CENTRAL FIRE STATION	REVISED COMM. LEVEL A/C PART. PLAN	DATE: 6-10-83 SHEET NO: 482-1	DESIGNED BY: LE CHECKED BY: EPB
HARRIS SHARP & ASSOC., INC. ARCHITECTURE-PLANNING-INTERIORS 2915 W. CHARLESTON BLVD. LAS VEGAS, NEVADA 89102 (702) 877-0125

jba CONSULTING ENGINEERS		Job No. 3115	
Job Title: CENTRAL FIRE STATION AIR CONDITIONING REVISION		By: L.E. Checked: E.P.B. Sheet: 1	Date: 6-6-83 Date: 6-6-83 Of: 1

REVISIONS AND/OR CLARIFICATION

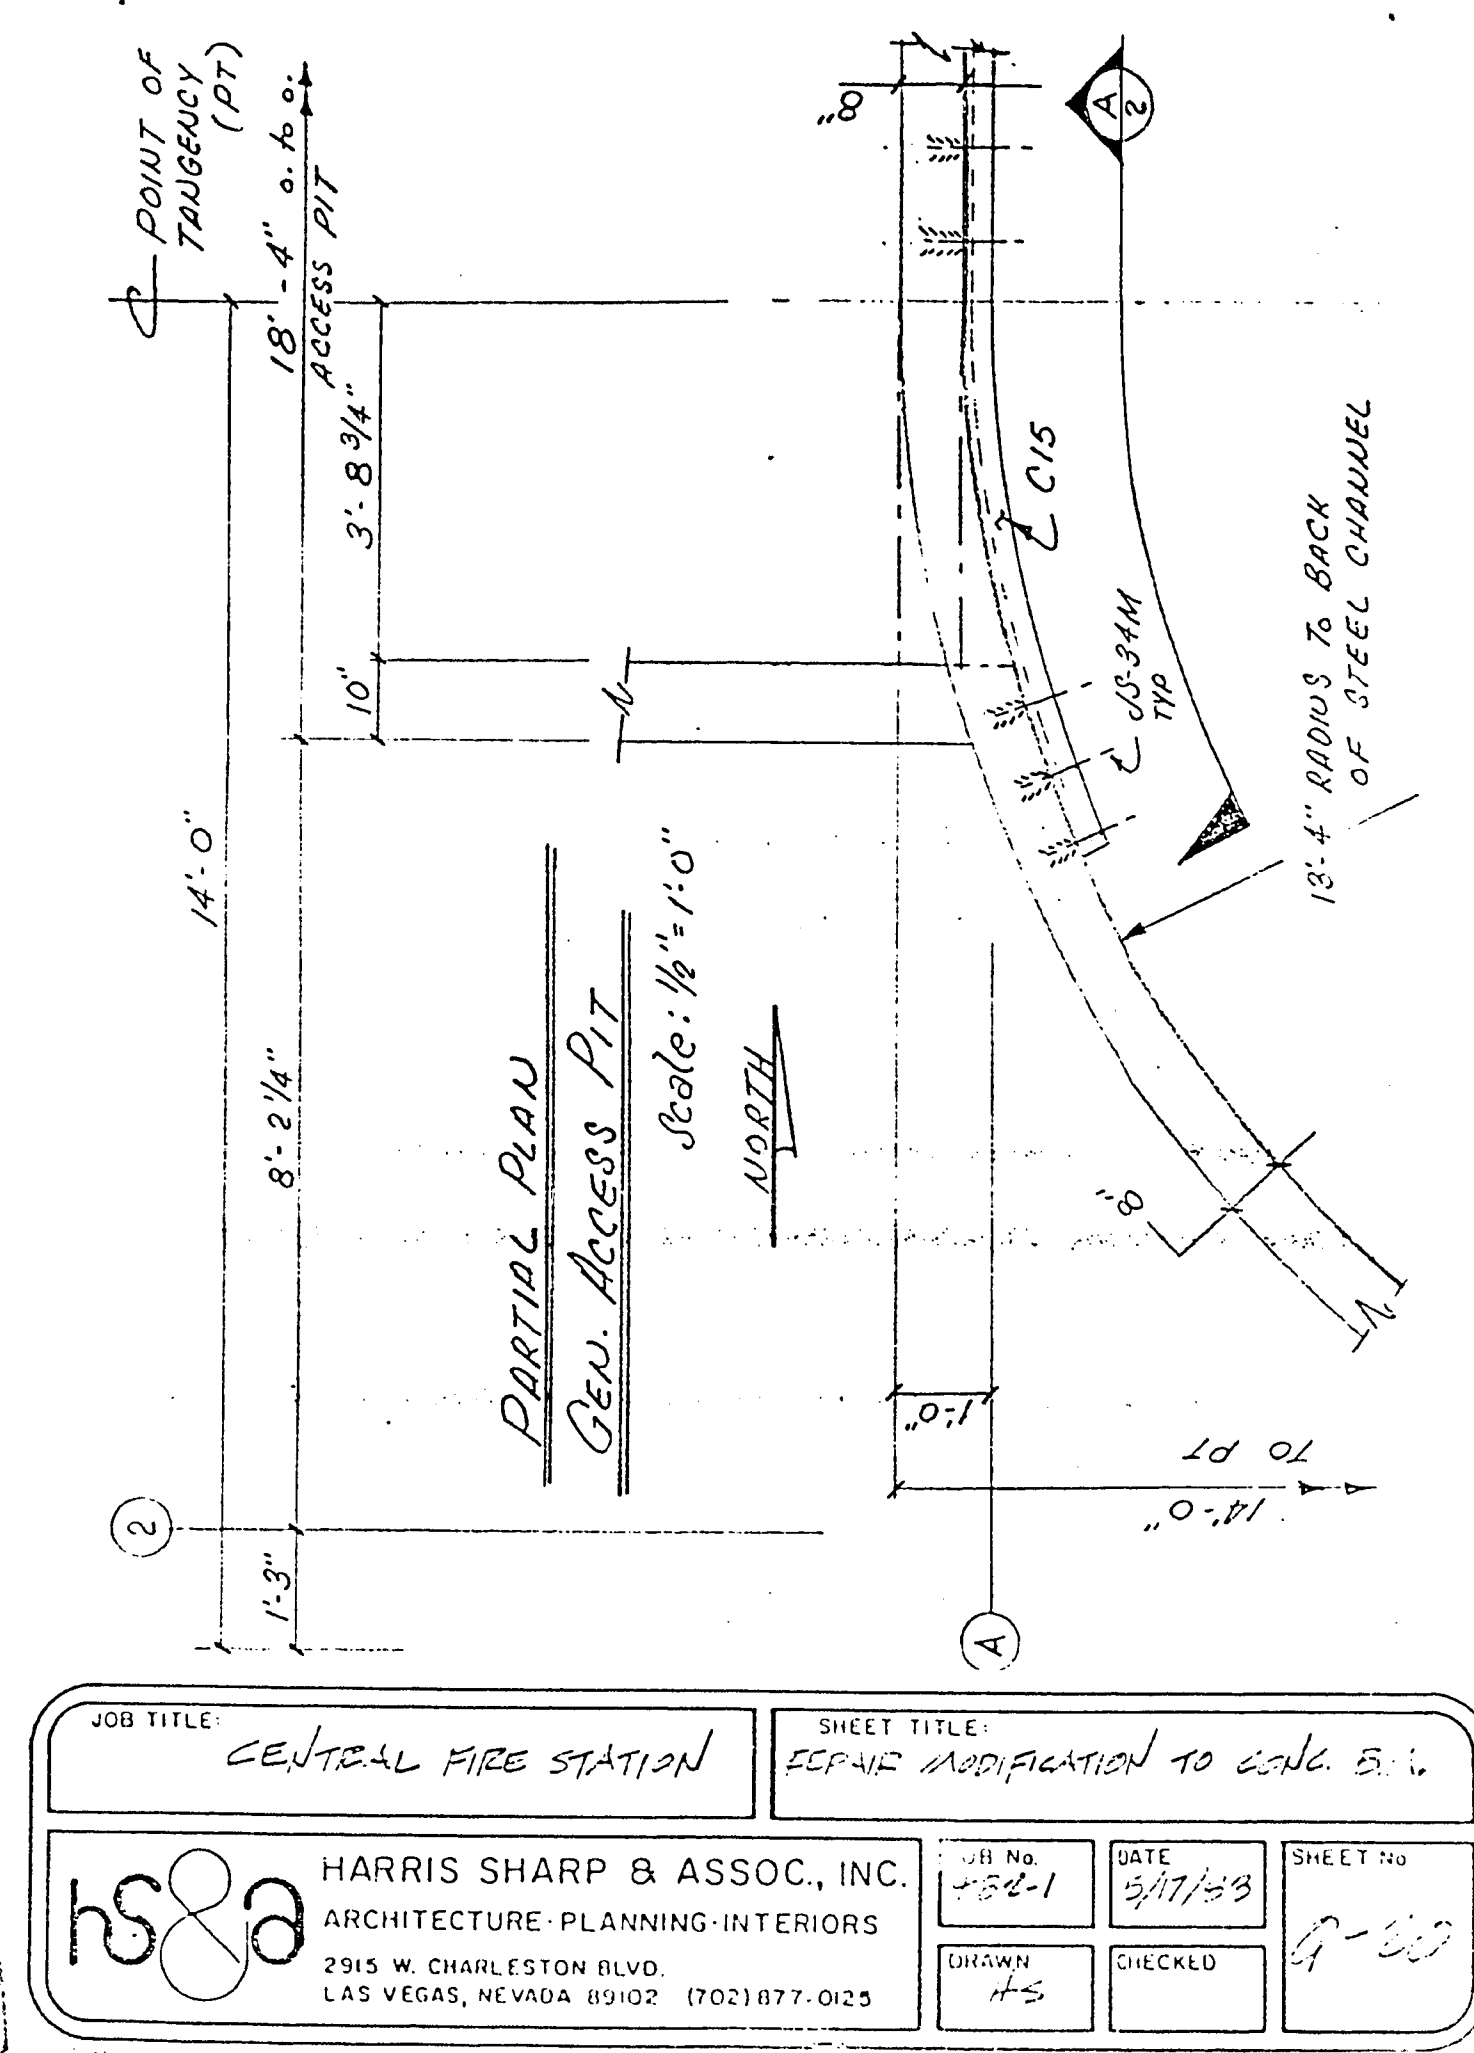
- NOTES**
- 18" ϕ DUCT TO BE RELOCATED.
 - RELOCATED 18" ϕ DUCT.
 - RISE BETWEEN WIDE FLANGE SIZE OF DUCTWORK TO REMAIN AS SHOWN ON ORIGINAL BID SET OF PLANS.
- GENERAL NOTES**
- REVISED DUCTWORK SHOWN HEAVY, LIGHT DUCTWORK AS SHOWN ON ORIGINAL BID SET.
 - REFER TO ORIGINAL BID SET OF PLANS FOR SIZES AND CONDITIONS NOT SHOWN ON THIS PART PLAN.
